# Permit Revision Submittal Requirements and Application

Value of Proposed Revision NA Issued Permit # 21-015814-000-CO

Existing tile shower to remain. No new ADA shower.

TENANT IMPROVEMENT FOR:  
PDX CODE GUILD

2  
A1.1 SECOND FLOOR PLAN WITH DIMENSIONS AND ELECTRICAL  
SCALE:3/16" = 1'-0"

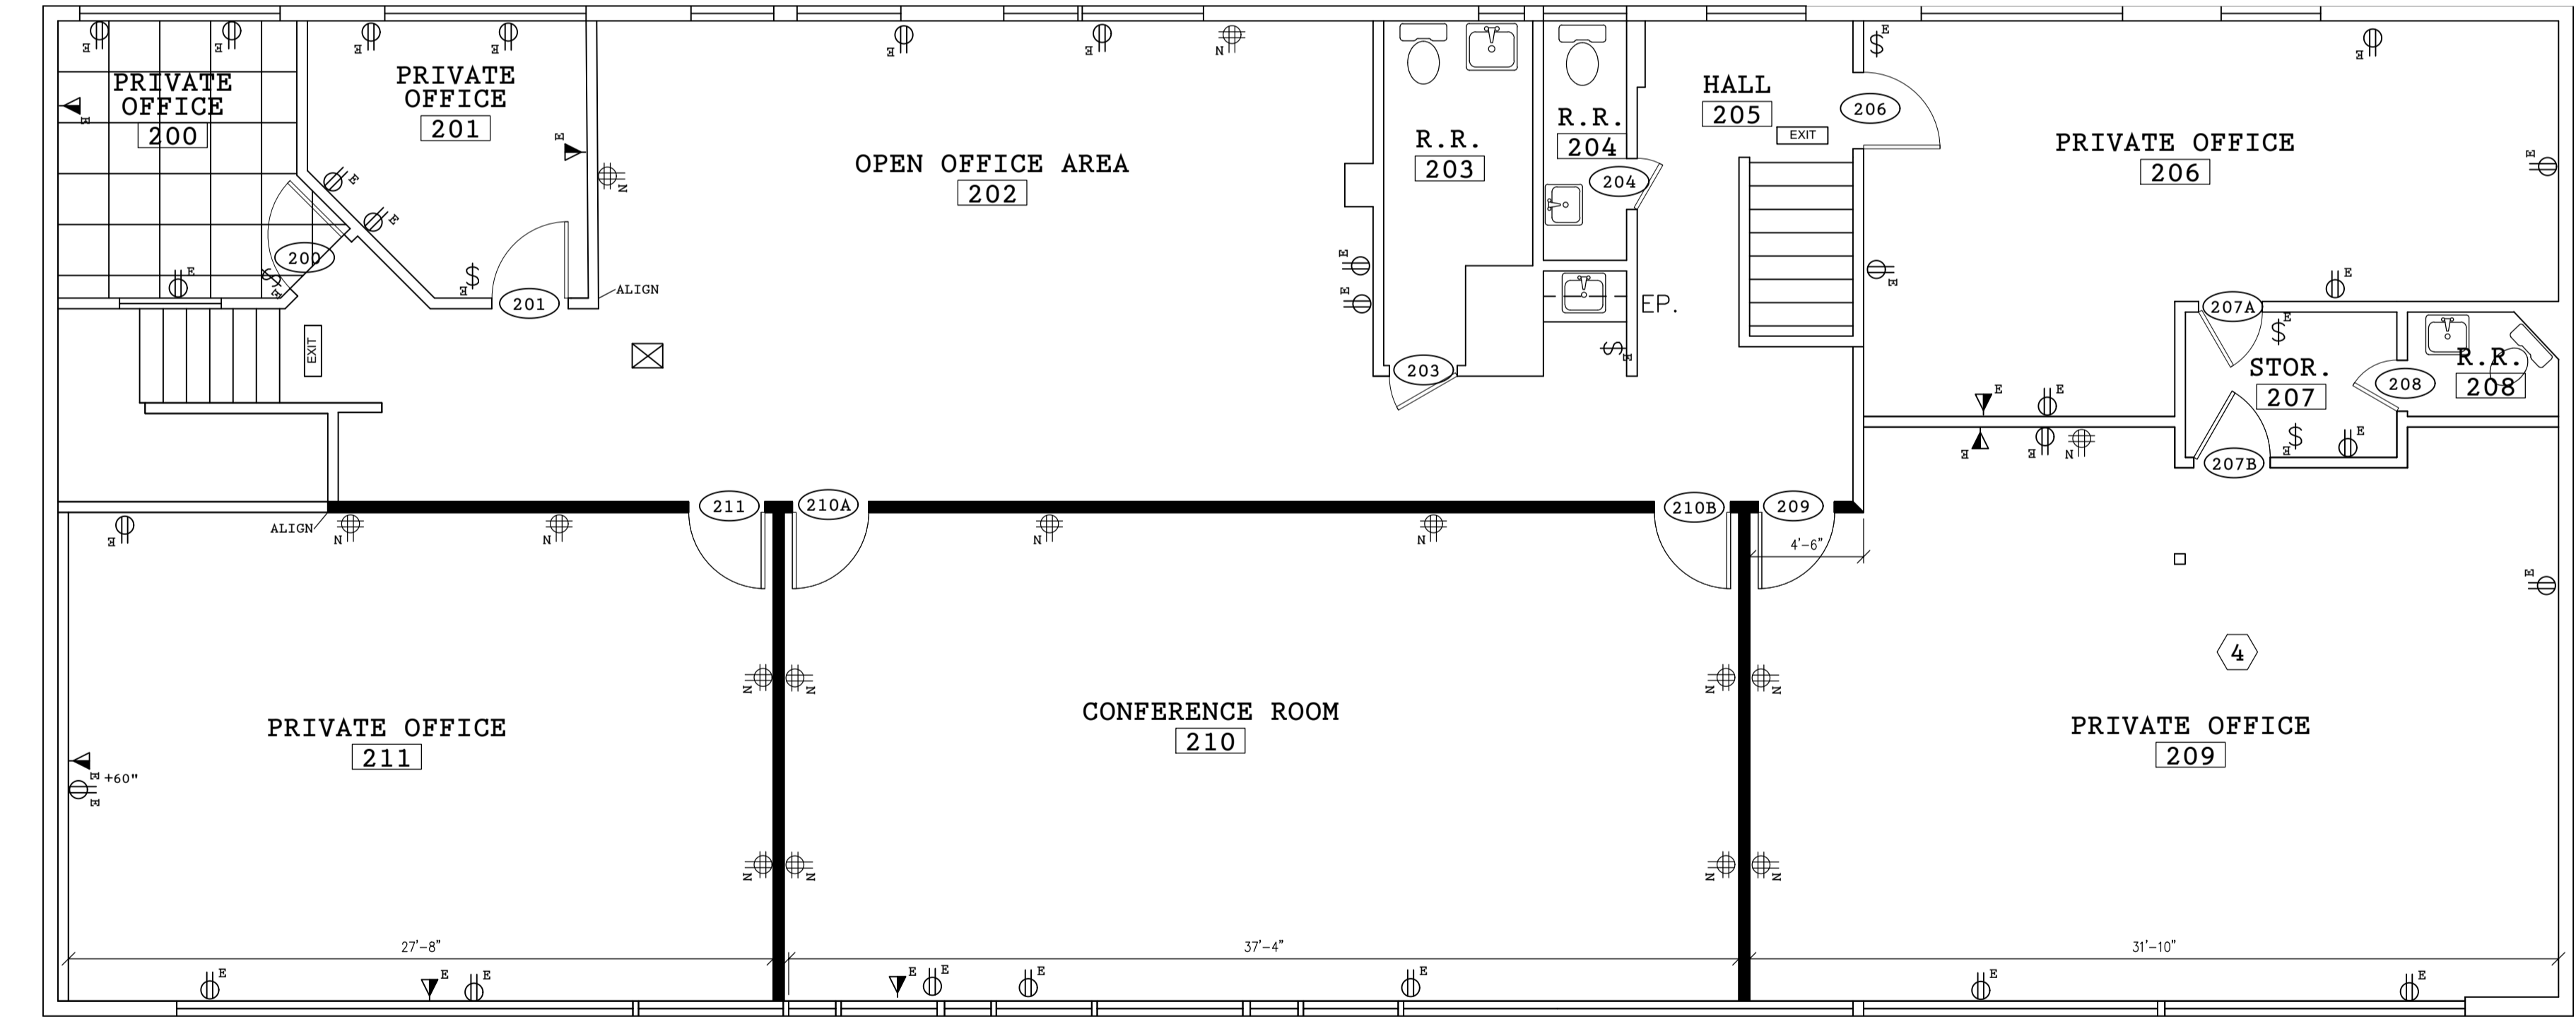
- ADD NEW SINK IN EXISTING CABINET
- SHOWER TO REMAIN THE SAME, NOT ADA.
- RELOCATE EXISTING BENCH
- OPEN OFFICE AREA #209; REMOVE EXISTING CROWN MOLDING
- RESTROOM #108; ADD NEW ADA SINK AND FAUCET. SINK: KOHLER - PINOIR - K-2028-1-0.
